- 6. Whiskey Gulch Lot 4 Replat; KPB File 2022-106
Ability Surveys / Stapel
Location: Stikens St., Thunder Rd. & Chopp St.
Anchor Point Area / Anchor Point APC**

ITEM 6 - Whiskey Gulch Lot 4 Replat

KPB File No.	2022-106
Plat Committee Meeting:	August 8, 2022
Applicant / Owner:	Richard and Loretta Stapel of Anchor Point, AK
Surveyor:	Gary Nelson / Ability Surveys
General Location:	Anchor Point / Anchor Point APC

STAFF REPORT

WHISKEY GULCH LOT 4 REPLAT

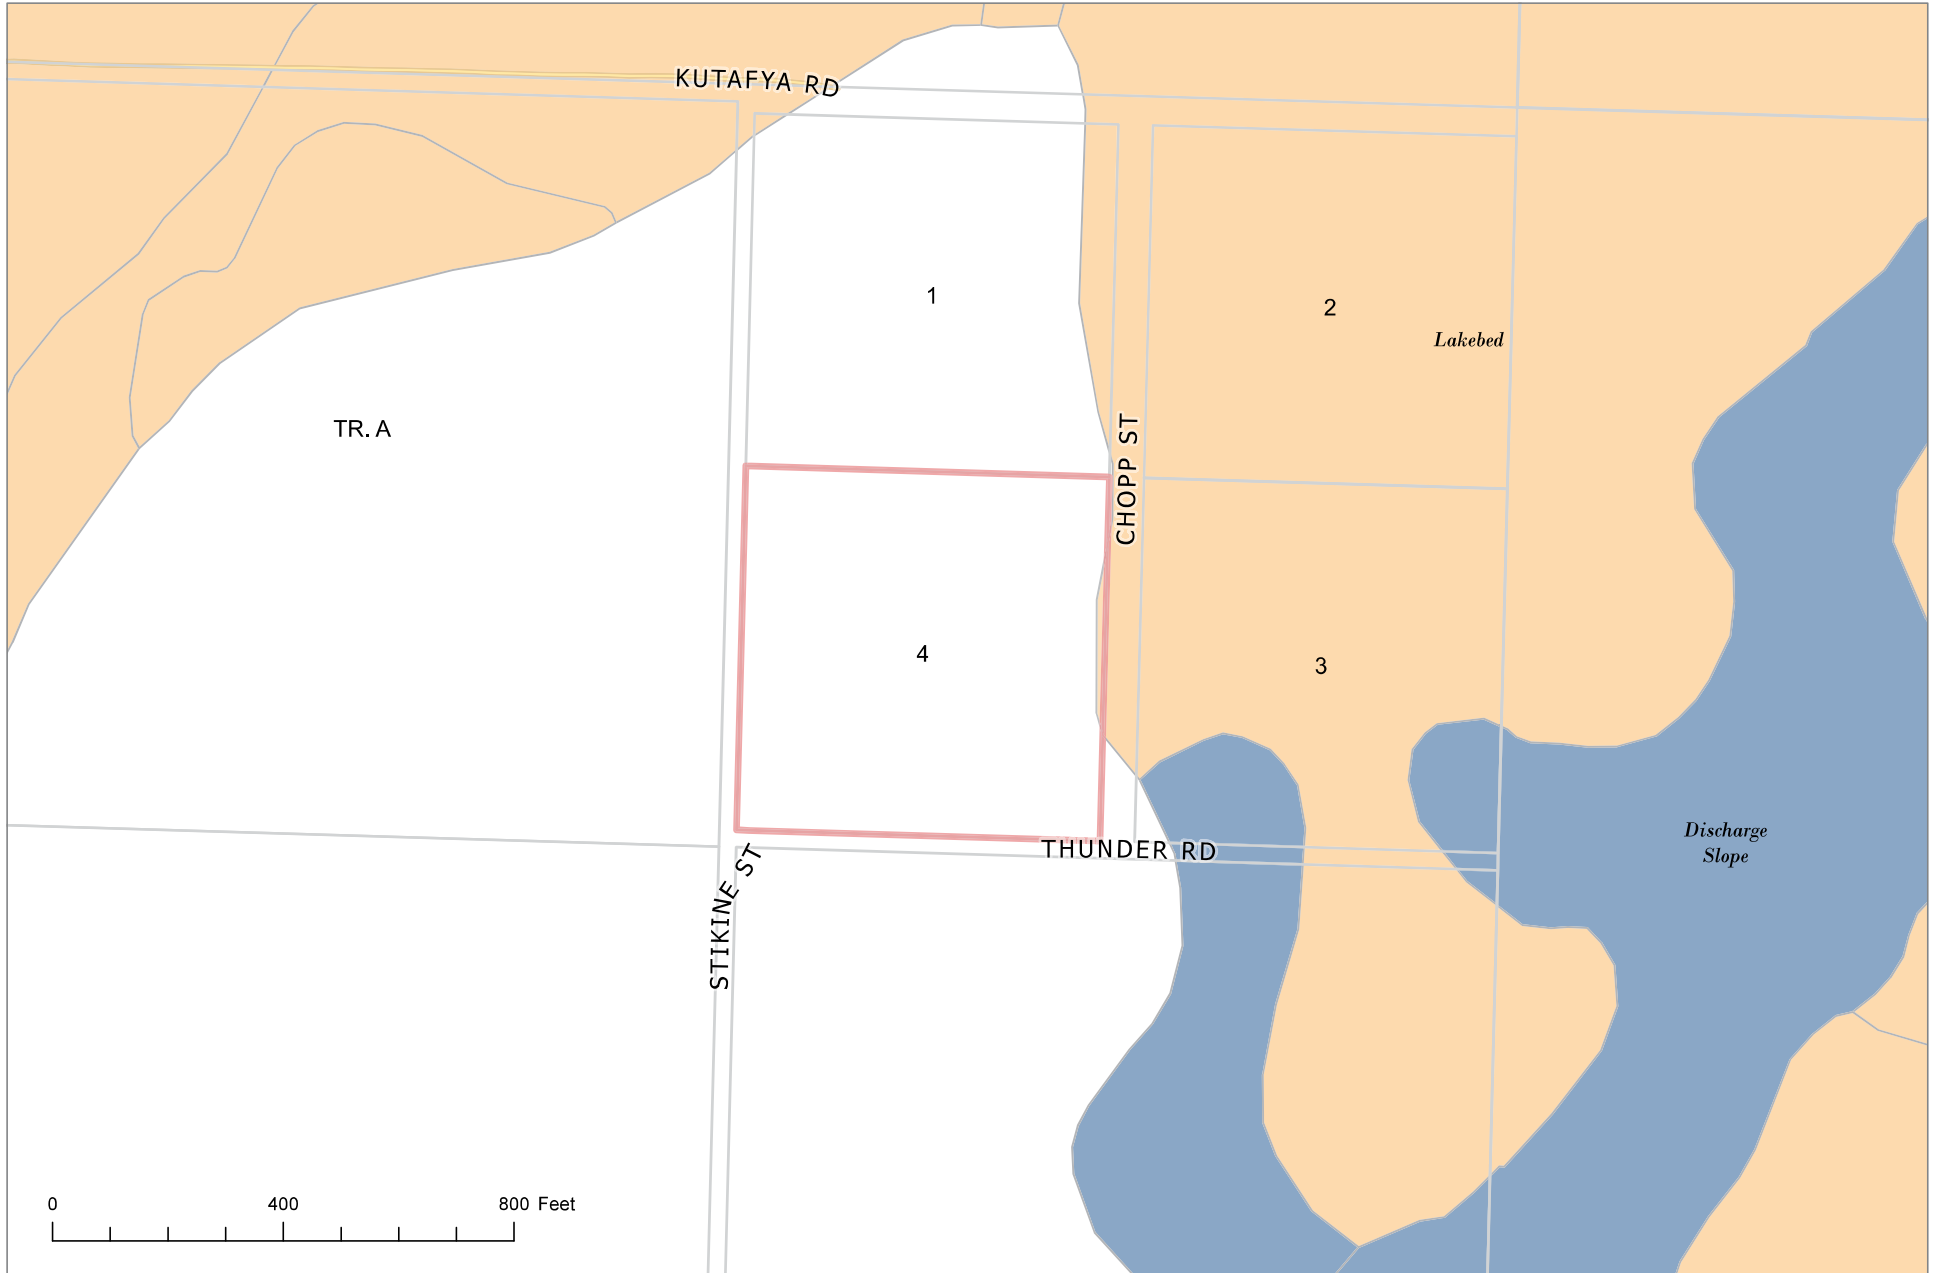
- B. North point;
Staff recommendation: Need to add scale to the drawing.
- G. The status of adjacent lands within 100 feet of the proposed subdivision boundary or the land status across from any dedicated rights-of-way that adjoin the propose subdivision boundary, including names of subdivisions, lot lines, block numbers, lot numbers, rights-of-way; or an indication that the adjacent land is not subdivided;
Staff recommendation: Need to add Block 1 to the tracts to the North, Northeast and East labels.

- A. The bearing and length of every lot line, block line, and boundary line shall be shown. Dimensions of lots shall be given as net dimensions to the boundaries of adjoining streets and shall be shown in feet. No ditto marks shall be used. Information shall be shown for all curves, including radius, central angle, arc length, chord length and chord bearing. The initial point of survey shall be shown and labeled. All non-radial lines shall be labeled. If monumented lines were not surveyed during this platting action, show the computed data per the record plat information. Need bearing and distance from the northwest corner to the E 1/16 corner.
Need a bearing on the west line of Lots 4A and 4B.
Correct the label on the corner to NE 1/16.

Add Waste Water note to Plat, reference requirement or exception as granted.

Staff recommendation: Add to the legend set pin label and detail, as well as and show what pins will be set on drawing.
